# 5F Apparels Ltd

28<sup>th</sup> January 2015

# Non Structural Observation

## Lack of edge protection

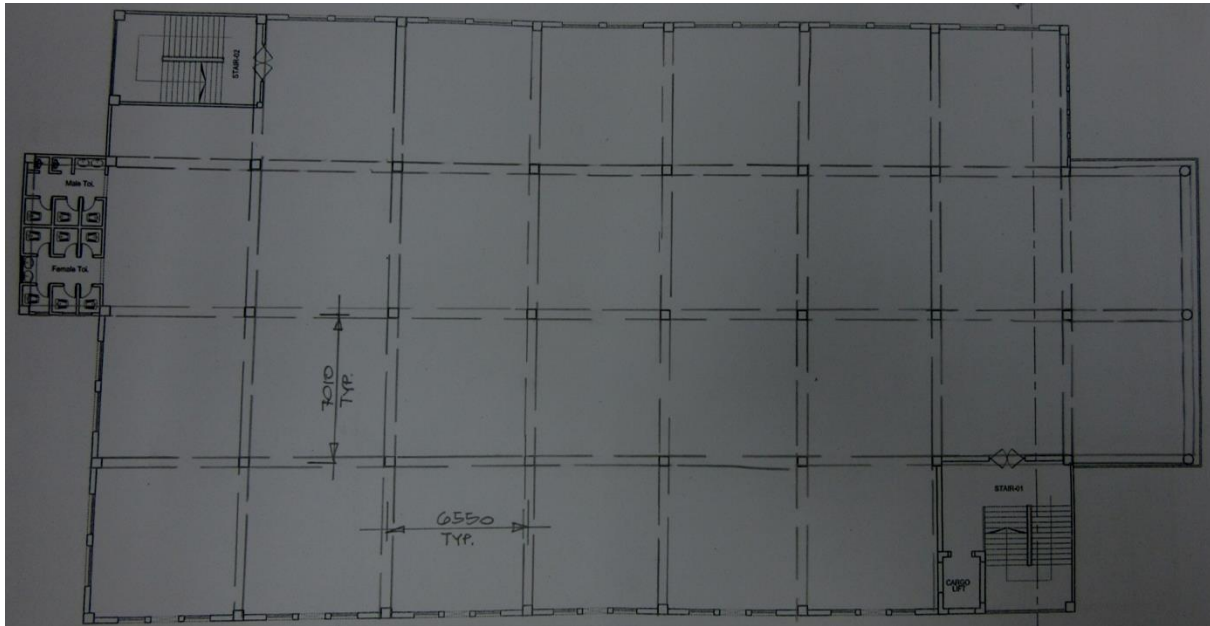
No edge protection was provided on the roof
